RE: Response to Comments, Bennoc Area NPDES OIL00159 Application for American Energy Corporation in Belmont County, Ohio

Response to OEPA Comments from Bruce Goff and Eric Nygaard Dated 8/21/12, 8/15/12, 7/20/12, 7/13/12, and 7/11/12 Bennoc NPDES Permit Application OIL00159

Hydro-Chemical Analysis of Waste Water Discharge and Anti-Degradation Assessment: American Energy Corporation's Bennoc Coarse Coal Refuse Area Ponds 001 and 002

Wheel treatment system – pictures provided by www.chemstream.com

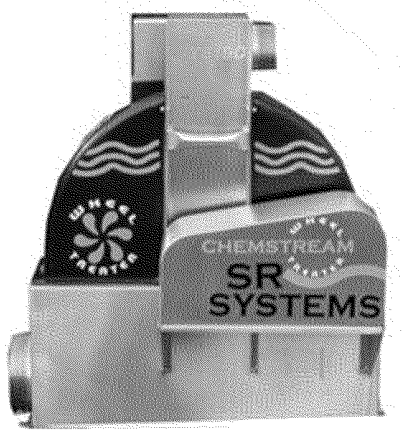
Comment: Do you happen to have any photos of the treatment ponds, the outlet structures, the chemical feed equipment and the discharge drainage ways (outlet ditches) you can share?

Response: We do not have any pictures of the proposed treatment ponds and their structures. However, we do have a picture (below) of the proposed wheel treatment system.

Section A'-A

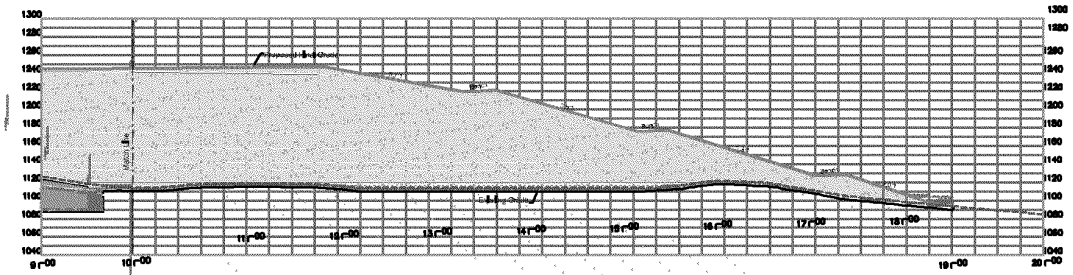
Comment: Also send us some typical cross sections of the refuse disposal area. Include a cross section before disposal of refuse, a cross section during disposal and a final cross section showing final grades and reclamation.

Response: Cross sections of the area for before disposal and after reclamation can be found in the attached drawing Sections A'-A & B'. During disposal cross-sections would be difficult to supply due to the constant change during construction.
